Subject: ADDENDUM No. 2, RFT 2025-011

Novar Covered Rink – Closing Date, Asphalt Apron, Septic Approval

NOVAR PARK RINK
54 McCRANDLE STREET
TOWNSHIP OF PERRY
DISTRICT OF PARRY SOUND

SCALE	DATE	DRAWING NO.
1 : 250	JULY 2025	SP-2
DRAWN	PROJECT NO.	
DPL	RH24-513

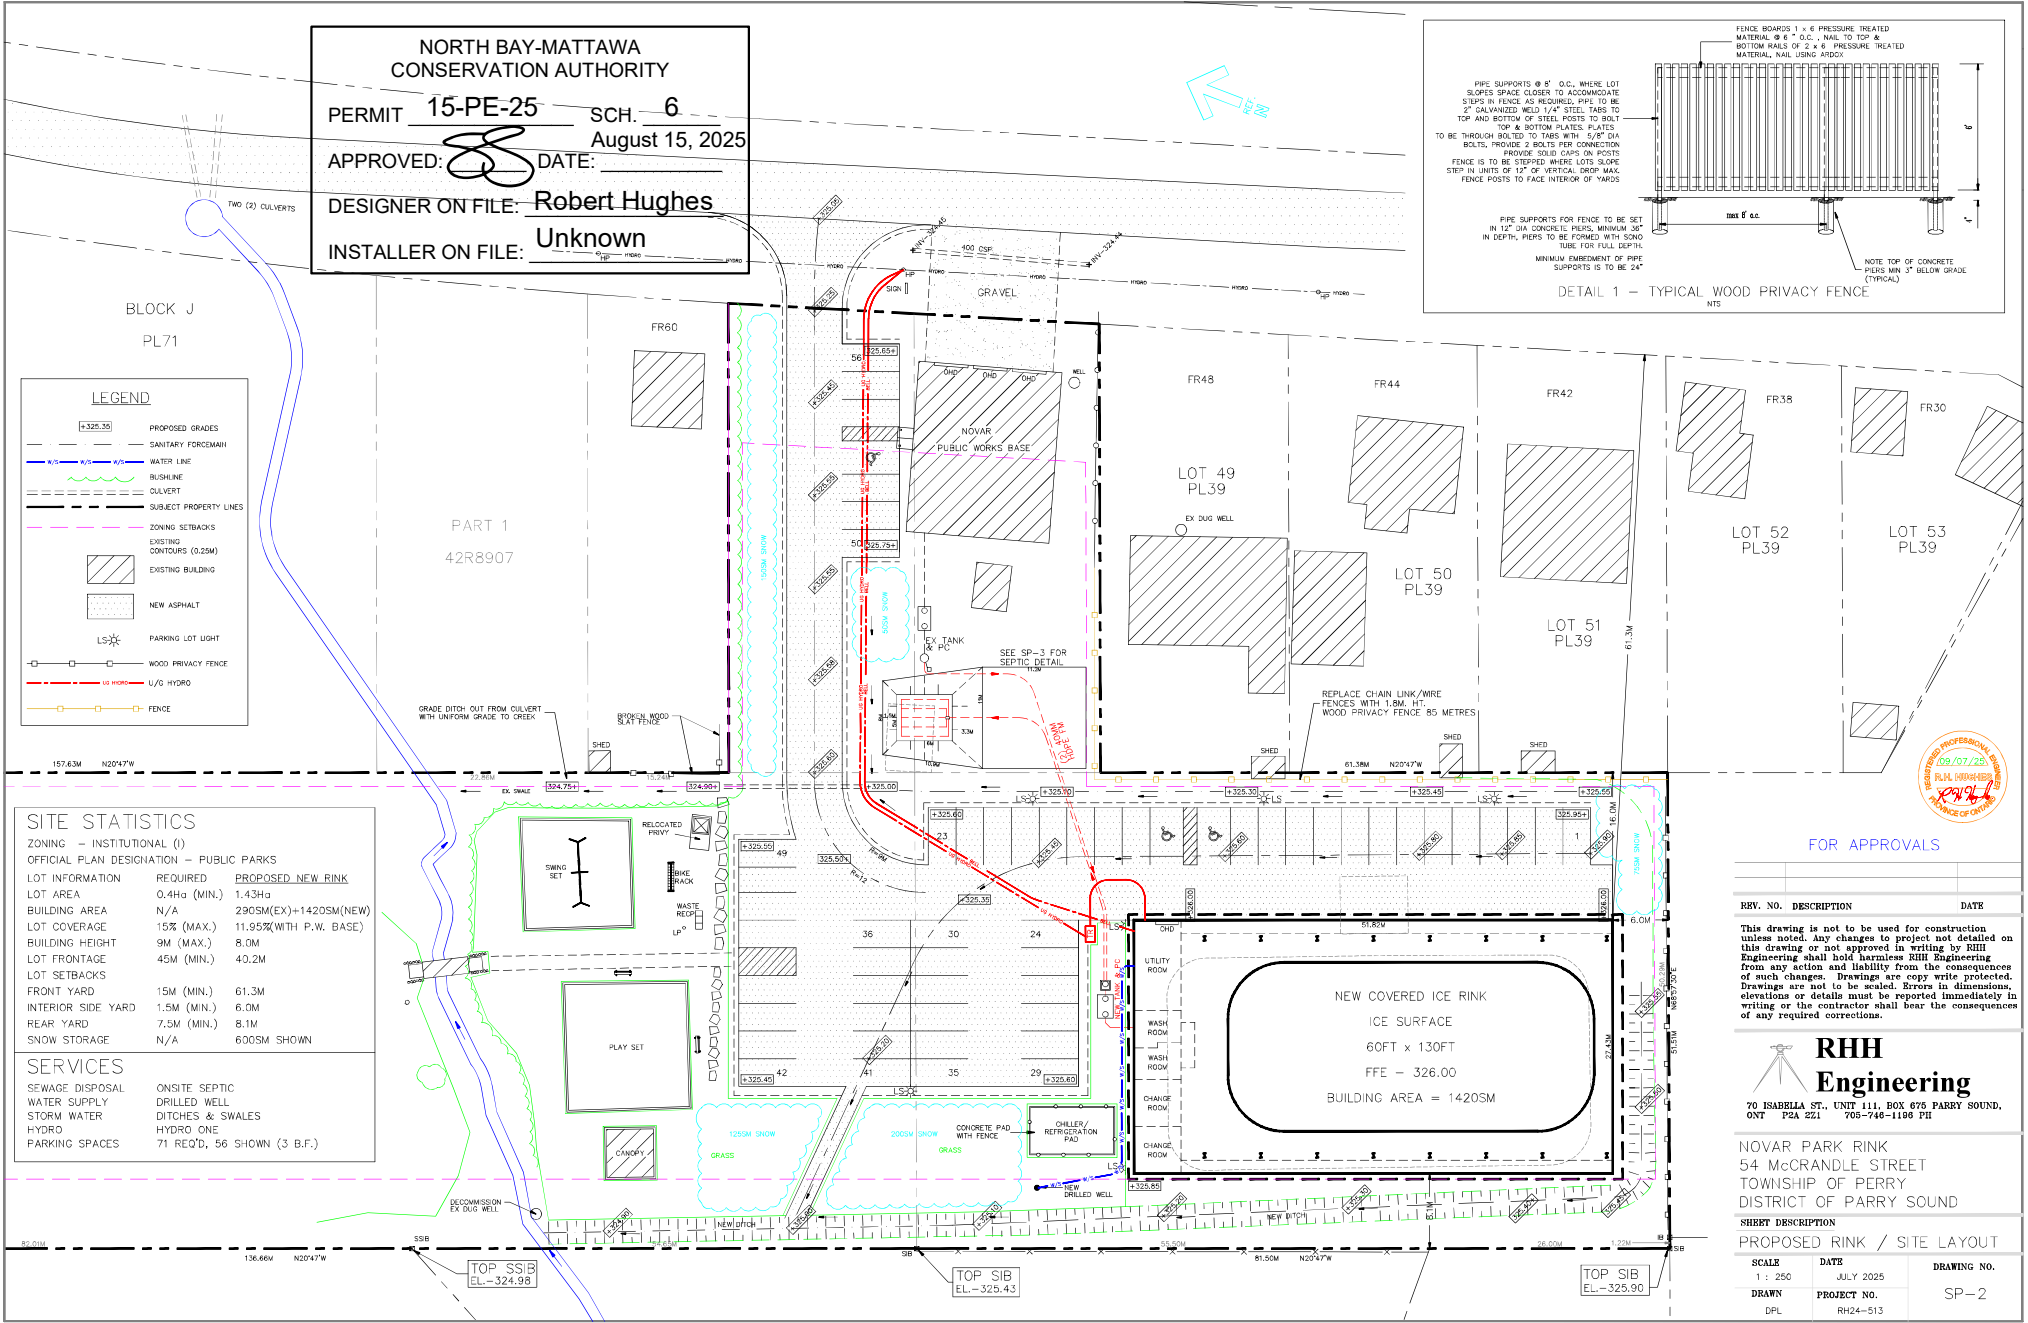
Project Drawing SP-2 shows a 14 metre wide x 15 metre asphalt apron to be installed between the Parks and Recreation Building and McCrandle Street. The Contractor shall additionally replace the existing 400 CSP culvert shown with a 375 mm CPP culvert to the approximate same grades as the existing. Additionally the contractor shall remove sufficient existing material to supply and install 150mm of granular A and 50mm HL4 to the approximate same finish grades. The granular A should extend 1 metre beyond the edge of asphalt edges shown.
